Addendum No. 1 Page 1

PROJECT: MODULAR CLASSROOM UNIT SITE PREPARATION

EFLAND-CHEEKS GLOBAL ELEMENTARY SCHOOL

CRA PROJECT #: 2231-EC DATE: 5/3/23

checked mh drawn Site Demolition

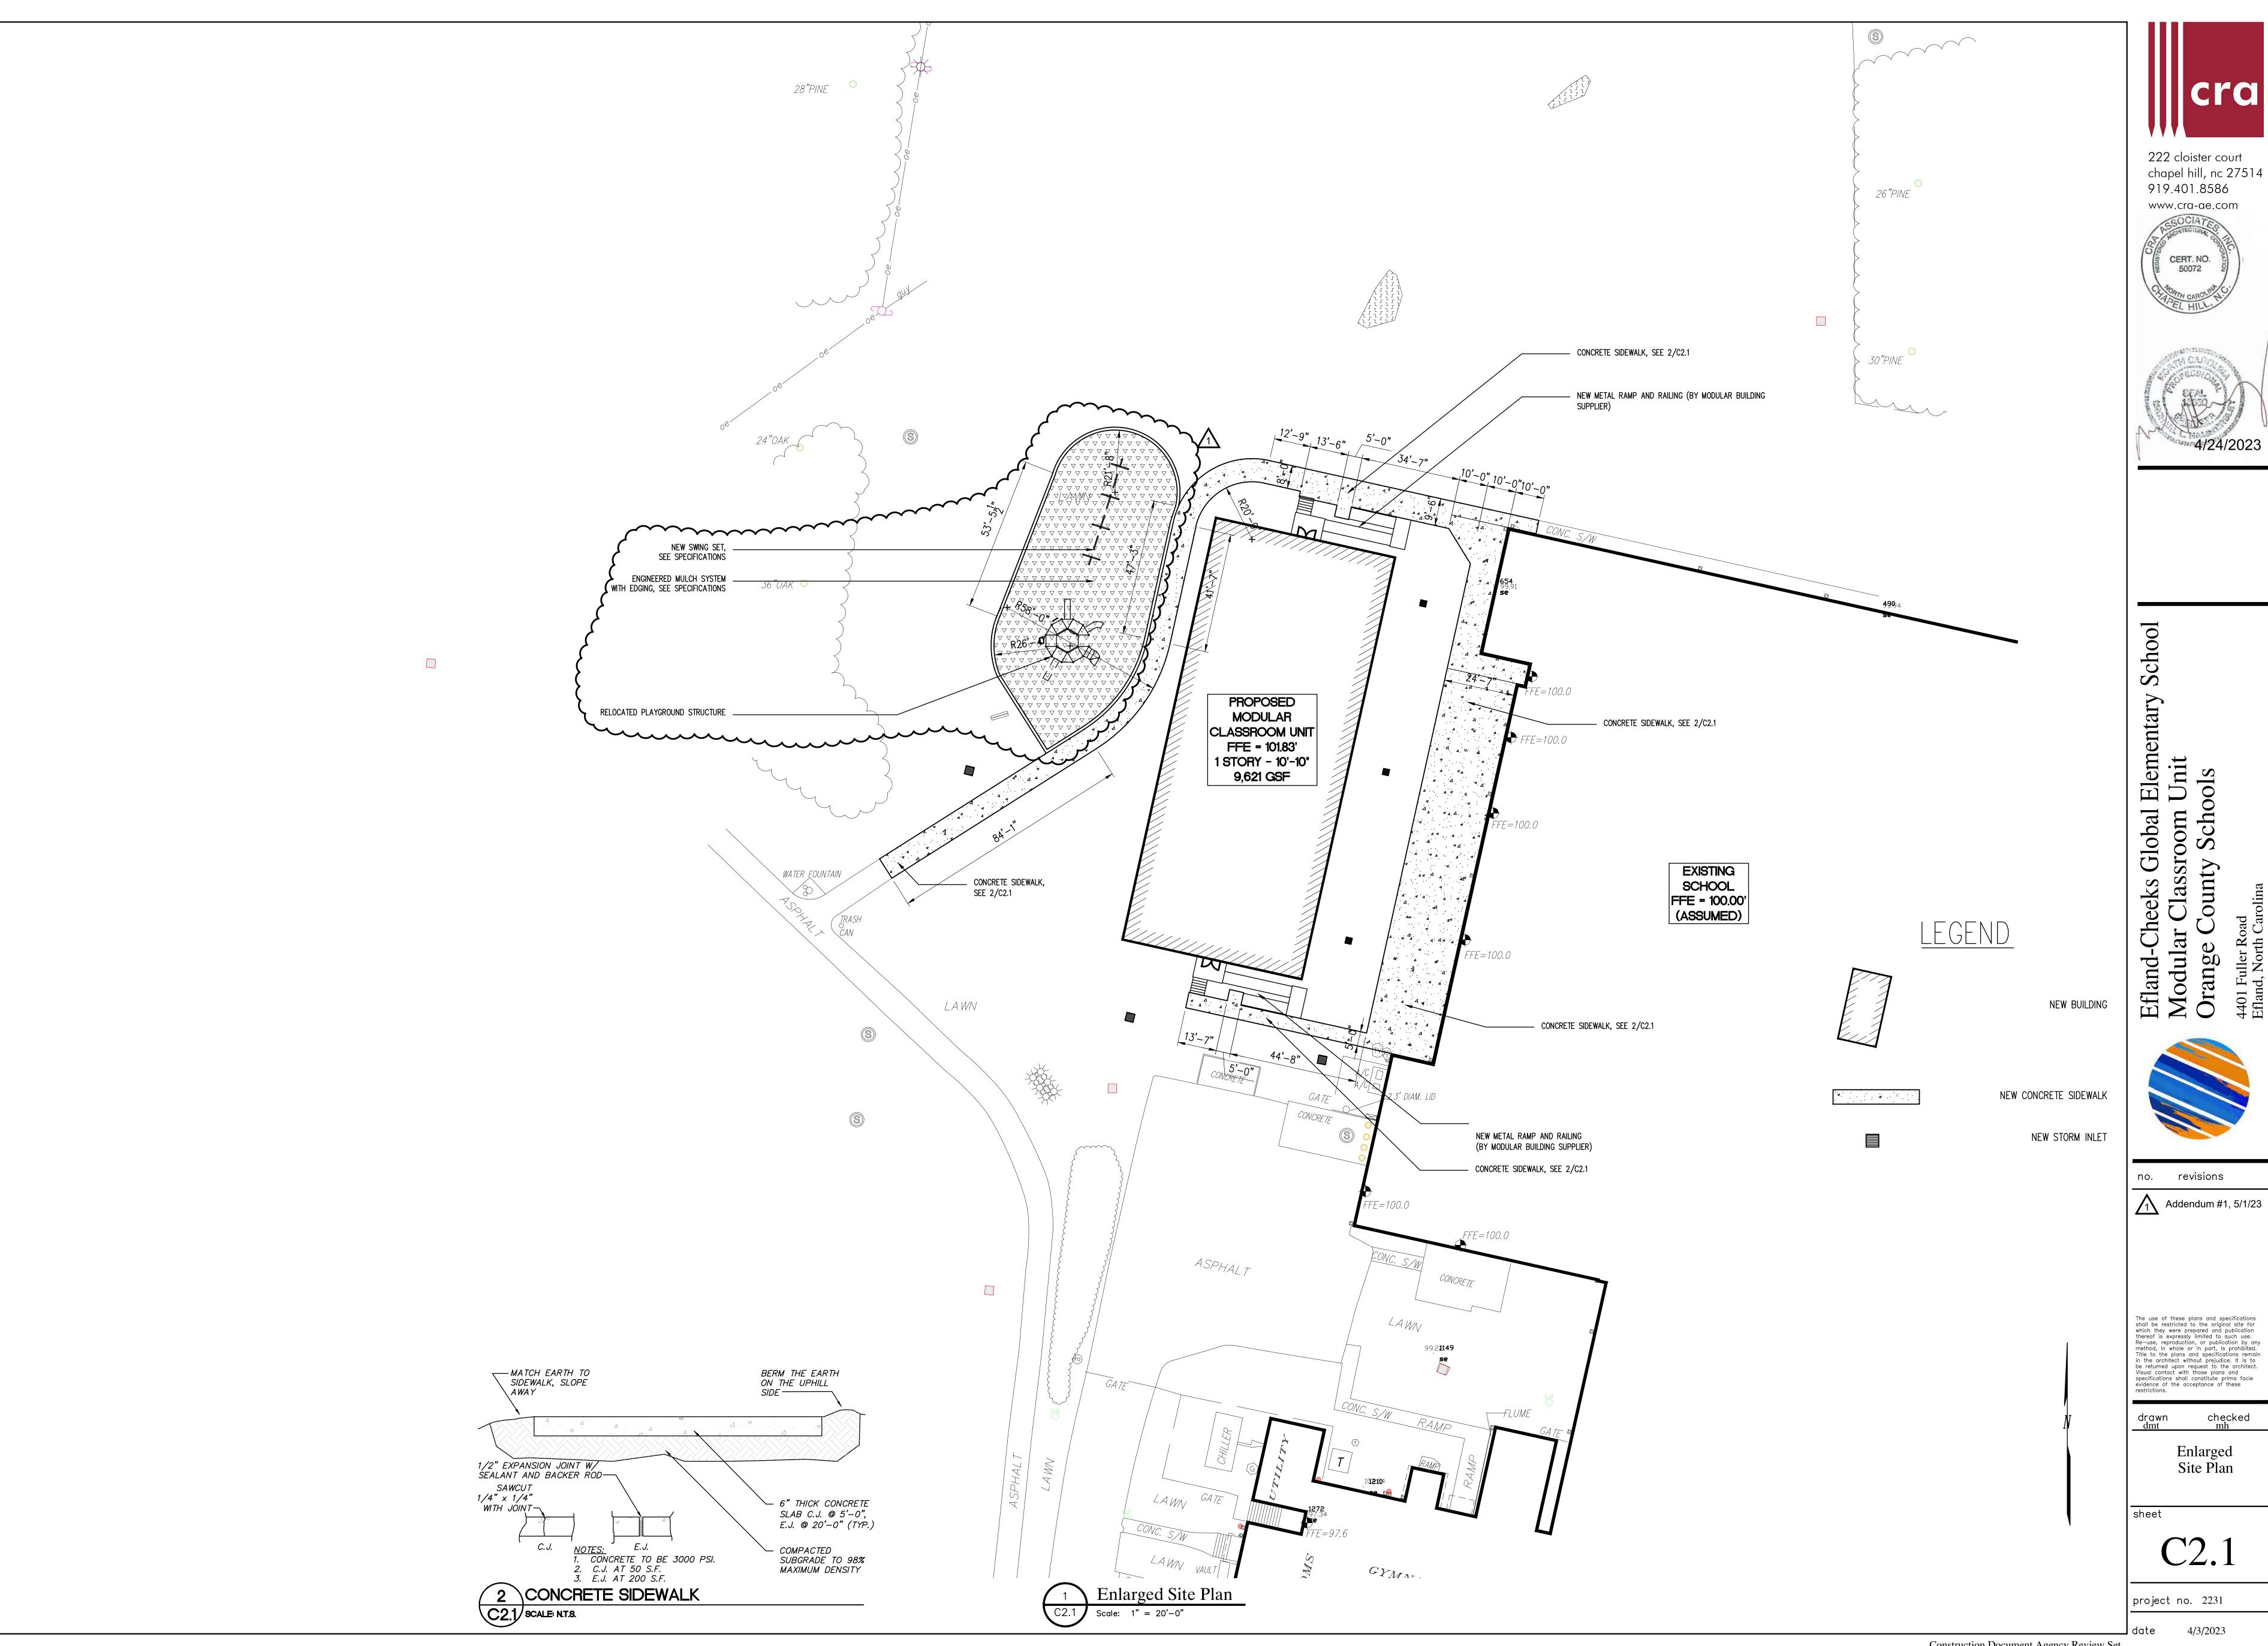
- 1. <u>Sheet C1.1:</u> replace Sheet C1.1 with the attached Sheet C1.1 (Addendum #1), which clarifies the extent of demolition of the existing playground equipment.
- 2. <u>Sheet C2.1:</u> replace Sheet C2.1 with the attached Sheet C2.1 (Addendum #1), which clarifies the extent of new and relocated playground equipment.
- 3. Sheet C3.1: replace Sheet C3.1 with the attached Sheet C3.1 (Addendum #1), which clarifies the extent of new and relocated playground equipment. Additionally, more information has been provided related to the new water line and the electrical conduits to the Modular Classroom Unit.

Enlarged Grading Storm Drainage & Utility Plan

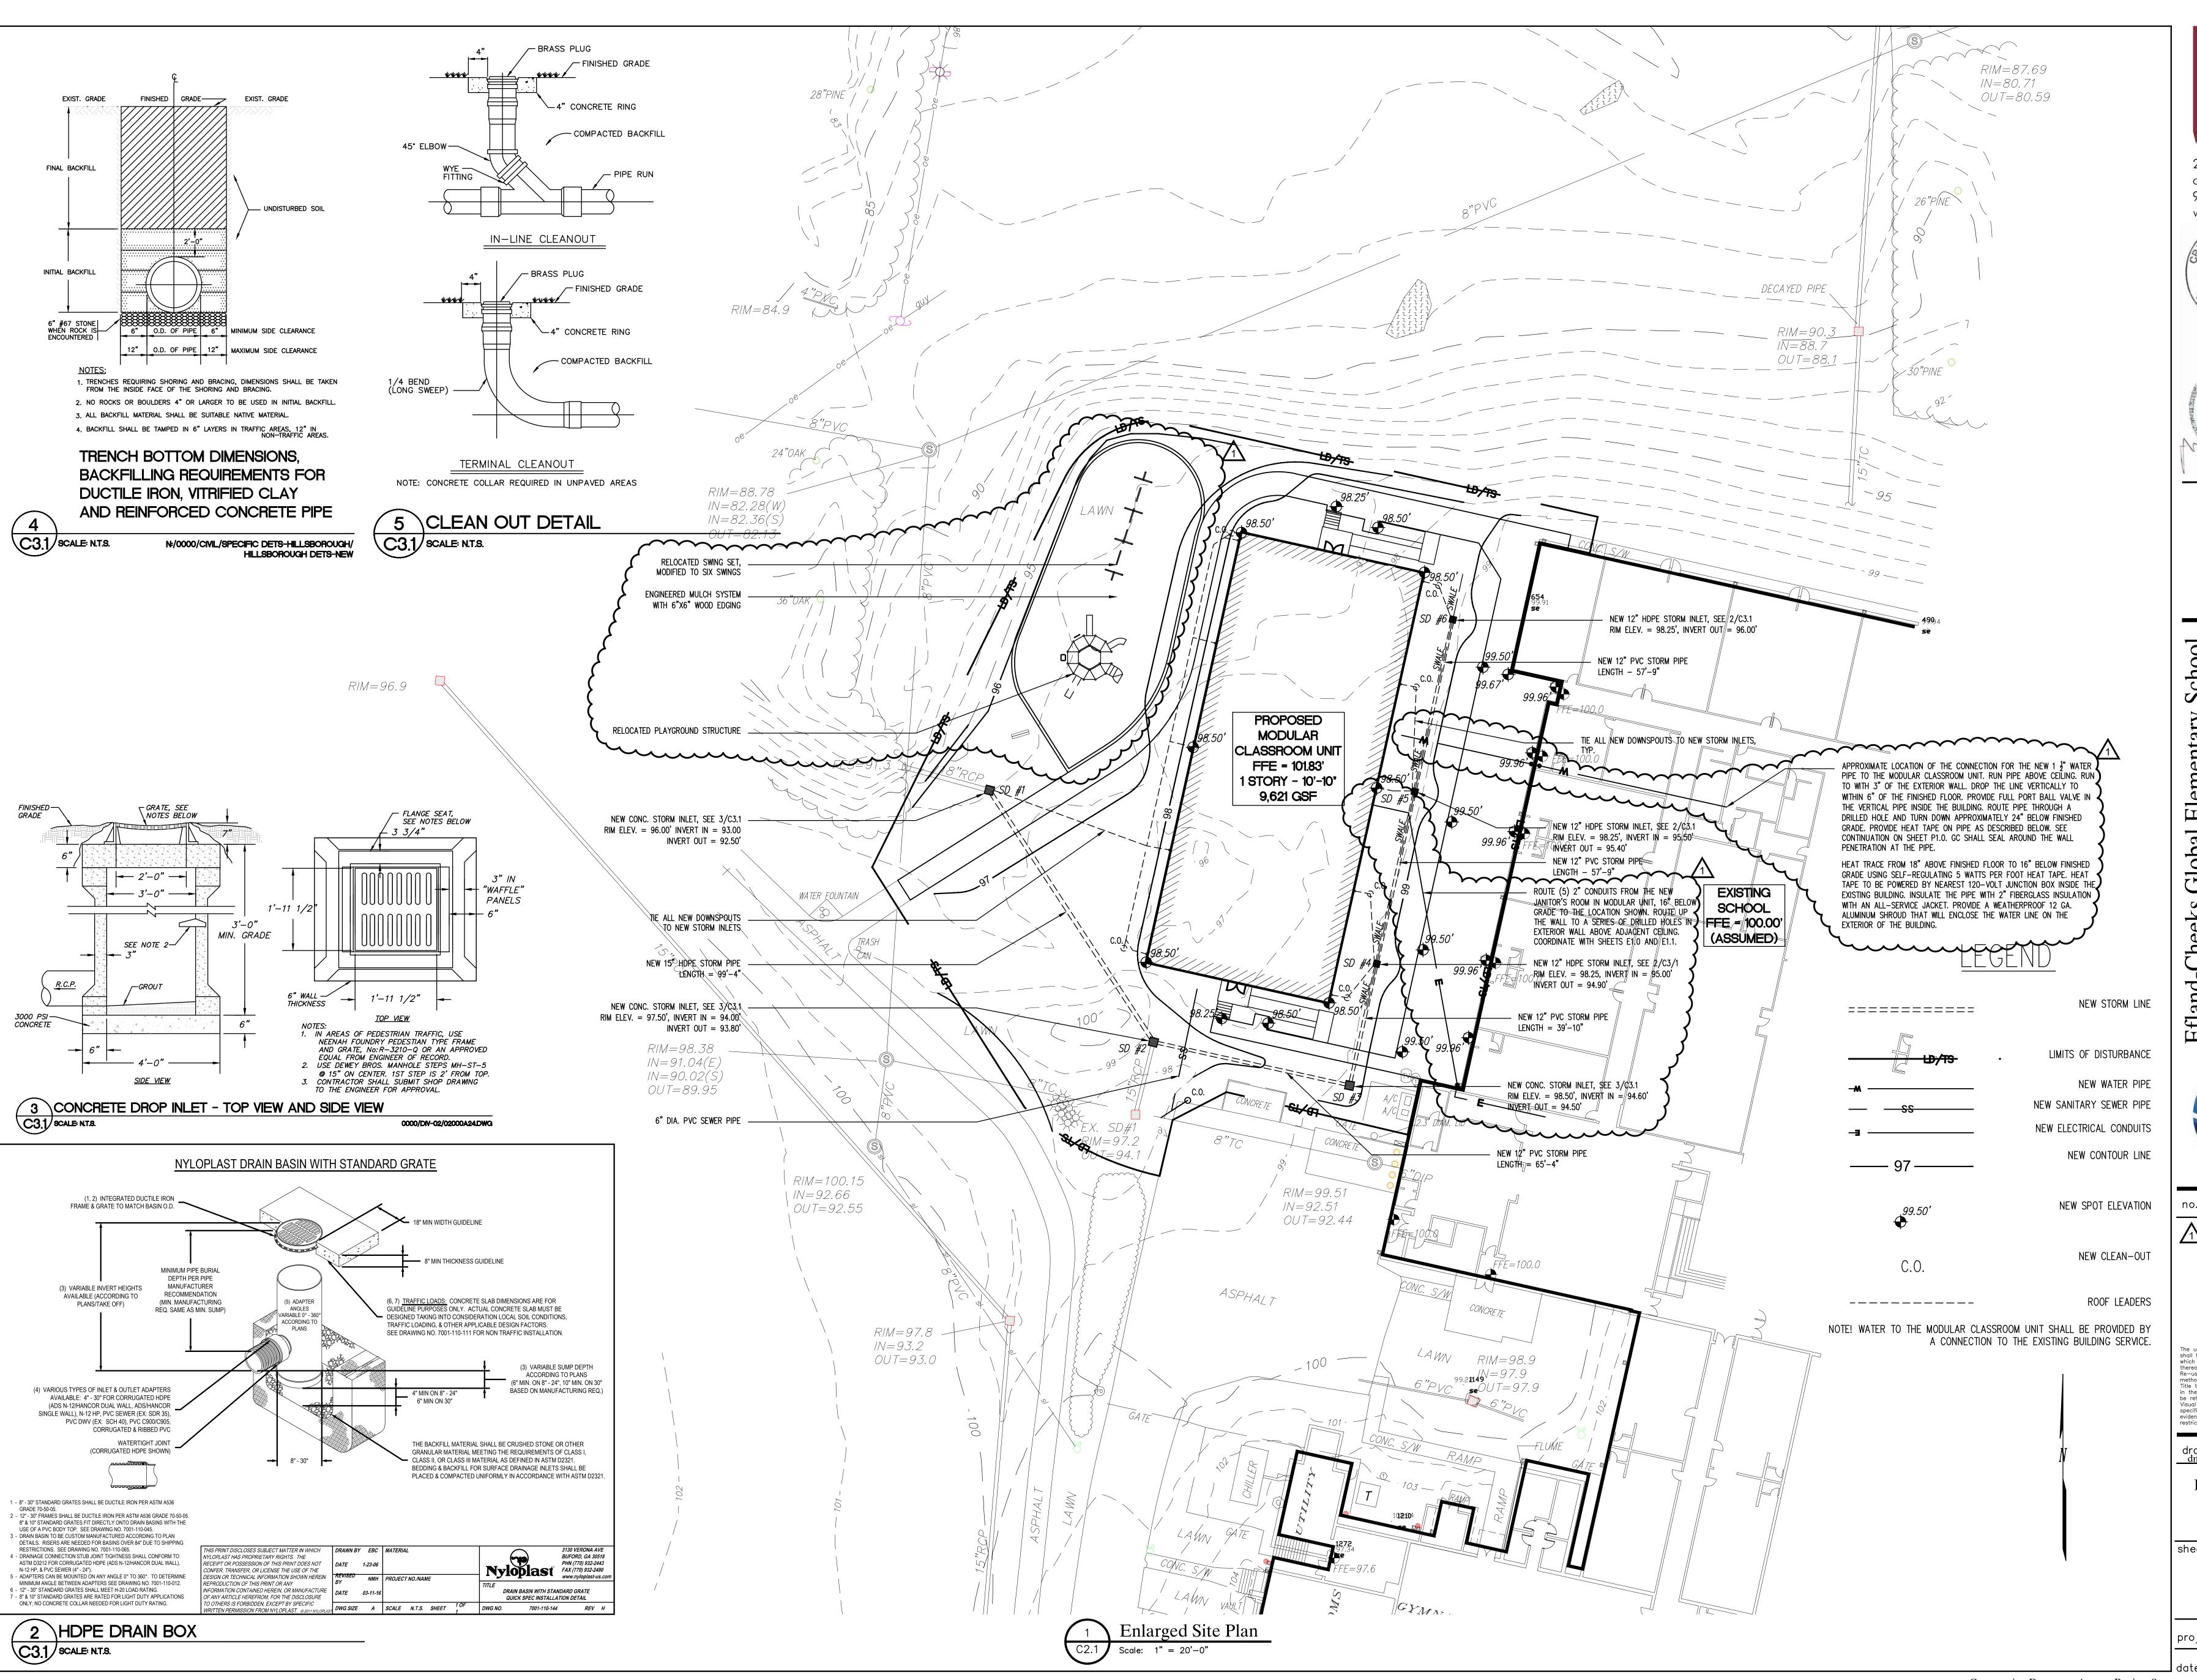
- 1. **Sheet E1.1:** clarify the following electrical issues.
 - a. Sheet C3.1 indicates the routing of the (5) 2" conduits for the telephone, fire alarm, security, intercom and fiber optic cables.
